Adamstown District Centre Phase 2 Block G Amendment

Stage 1 Road Safety Audit

Quintain Developments Ireland Ltd

October 2021

Figure 2-1 – 6m Junction Radii

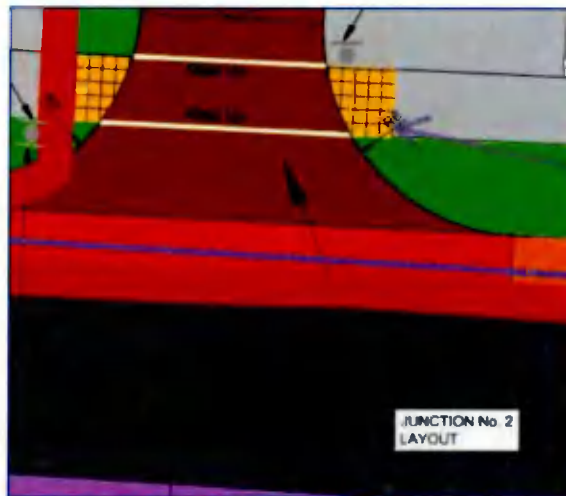
2.1. Problem: Junction Radii Leading to Higher Speed

Location: Junction 1 and Junction 2

The proposed radii of 6m may lead to higher driving speeds. This may increase the risk of conflict with crossing pedestrians, or other road users, where drivers are travelling through the junctions at higher speed.

The Design Team should investigate the provision of smaller radii to encourage slower driving speeds through the junctions.

2.1	Y	N	The concern is noted however the 6m junction radii provided onto external roads is to provide for ease of access for larger vehicles serving the development, refuse and delivery vehicles; these are expected to be higher in magnitude due to the presence of the apartment blocks. This aligns with SDCC Road departments junction radii recommendations. The layout will allow entry and exit of a small and large vehicle at the same time without blocking of the junction which could lead issues between opposing traffic. The provision of the raised table is deemed the key factor in reducing speed and highlight the crossing thereby negating the concern associated with the 6m radius.	Yes

Figure 2-3 - Proposed Temporary Bus Stop

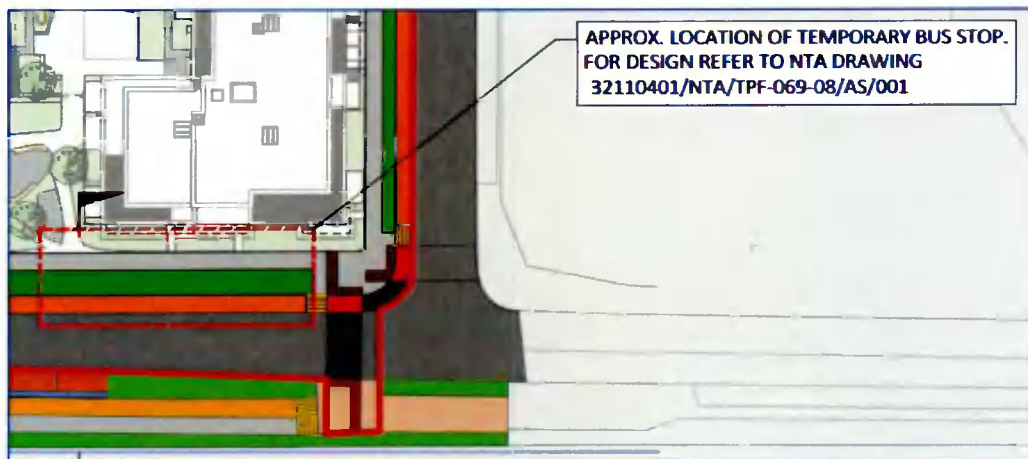
2.3. Problem: Bus Stop In front of Pedestrian Crossing

Location: Station Road

The drawings indicate a temporary bus stop may be provided on Station Road, as shown in Figure 2-3. When a bus is stopped here it may block visibility to the pedestrian crossing and/or signals to the east. Vehicles passing/overtaking the stopped bus may fail to see the red light ahead, and could collide with pedestrians crossing or other road users at the junction.

The Design Team should consult with the NTA on the proposed temporary bus stop location and ensure visibility to the pedestrian crossing is not adversely affected.

2.3	Y	Y	Prior to installation and operation of this temporary bus stop the Design Team will consult with the NTA on the proposed temporary bus stop location and ensure visibility to	Yes

Figure 2-4 - Junction No 1 crossing

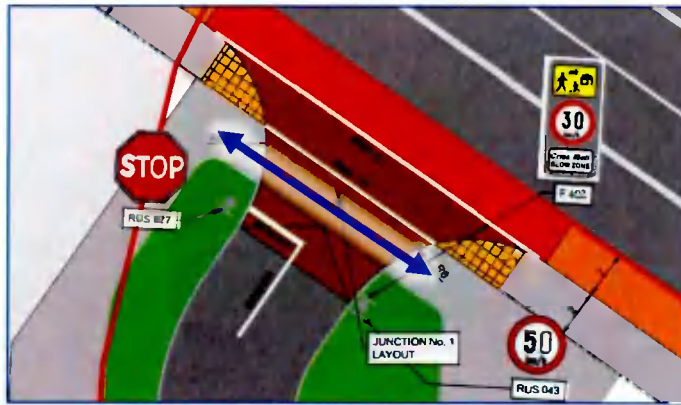
2.4. Problem: Potential for Informal Crossing

Location: Junction 1

The termination of the footways at Junction 1, as highlighted in Figure 2-4, may encourage pedestrians to cross at an undesignated point in the junction. This could lead to trips/falls as the ramp transition will result in a low kerb upstand at this location, which may be unseen by those crossing.

The Design Team should propose means to discourage crossing here, such as extending the grass verge northwards, up to the designated crossing point.

the pedestrian crossing is not adversely affected	
2.4	Y	Y	Crossing to be adjusted	Yes
2.5	Y	Y	Raised crossing detail to be reviewed at detailed design stage	Yes
2.6	Y	Y	Landscape areas to be extended to reduce uncertainty over informal crossing locations.	Yes
2.7	N	N	Road has been designed in compliance with DMURS principles as allow traffic low speed environment, with a design speed of 30kph.	Yes

Figure 2-5 - Kerb between raised crossing and cycle path

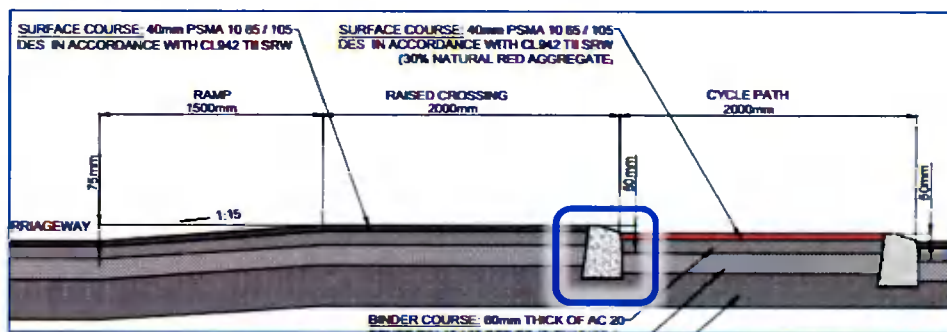
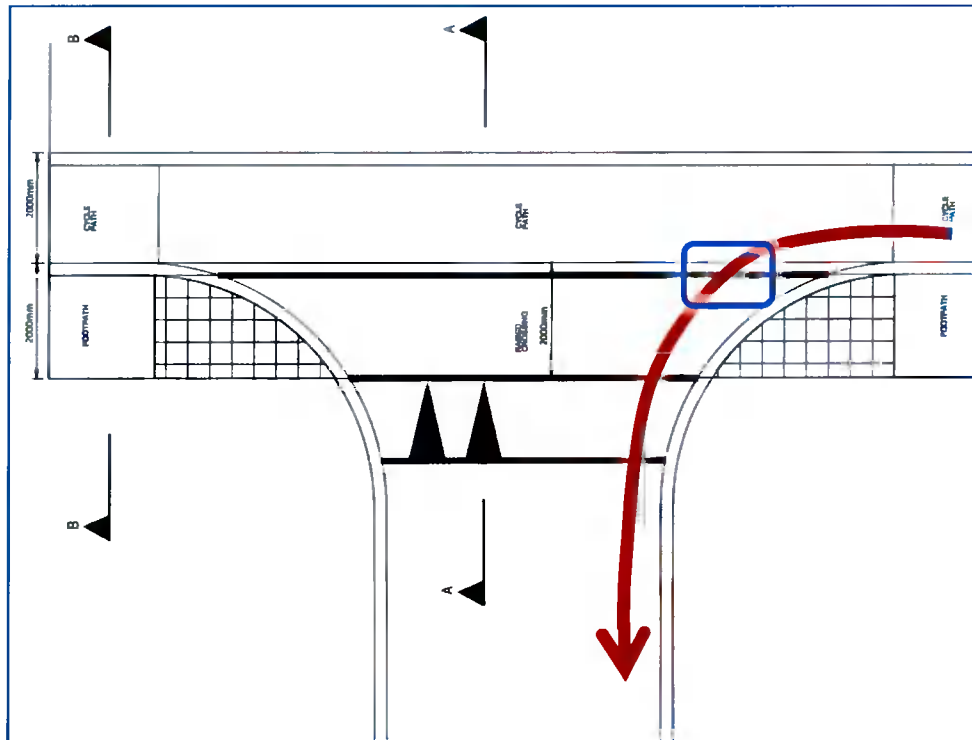
2.5. Problem: Kerb Destabilising Cyclists

Location: Junction 1 and 2

The cycle path is proposed to be raised by 50mm across Junction 1 and 2, with a further 50mm vertical difference to the raised crossing; as shown in Figure 2-5. A bevelled 50mm kerb is proposed between the cycle path and raised crossing. Left turning cyclists will be crossing this kerb at an acute angle, as shown in Figure 2-6. This may cause the front wheel of the bicycle to lose traction as it is crossing the face of the concrete kerb, particularly in wet/icy conditions, which could destabilise the cyclist resulting in a fall.

The Design Team should review the proposed raised crossing detail with consideration for left turning cyclists.

Figure 2-8 – Parking at Crossing Points

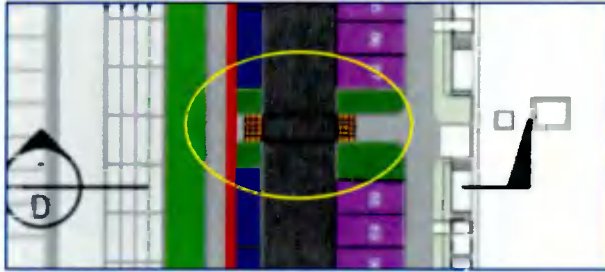
2.7. Problem: Visibility at Pedestrians Crossings

Location: Pedestrian Crossing

The presence of parked cars may lead to restricted visibility at the pedestrian crossings; particularly a larger vehicle such a van, truck or jeep. This may lead to drivers conflicting with pedestrians attempting to cross.

The Design Team should ensure adequate visibility is provided at the crossing points only; this may be achieved by setting back the adjacent car parking spaces.
